Proposal #03: 2025-19-70
W Capitol Drive
North Green Bay Avenue to
North 2nd Street
STH 190
Milwaukee County

This is Addendum No. 02, which provides for the following: for Project ID 2025-19-70

ADDENDUM NO. 02

Addendum No. 02
 ID 2025-19-70
 Revised Sheet 365
 January 31, 2019

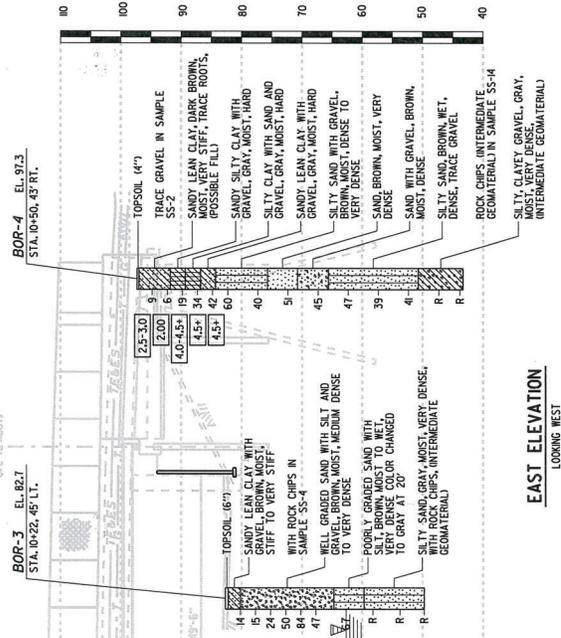
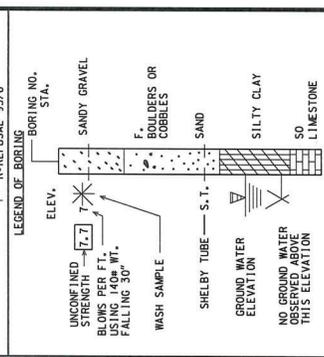
Revised Plan Sheets	
Plan Sheet	Plan Sheet Title (brief description of changes to sheet)
365	Structure R-40-656 Quantities & Subsurface Exploration Layout (updated bid item call-off)
367	Structure R-40-656 Railing Tubular Steel (added details, updated notes)
369	Structure R-40-657 Quantities & Subsurface Exploration Layout (updated bid item call-off)
371	Structure R-40-657 Railing Tubular Steel (added details, updated notes)
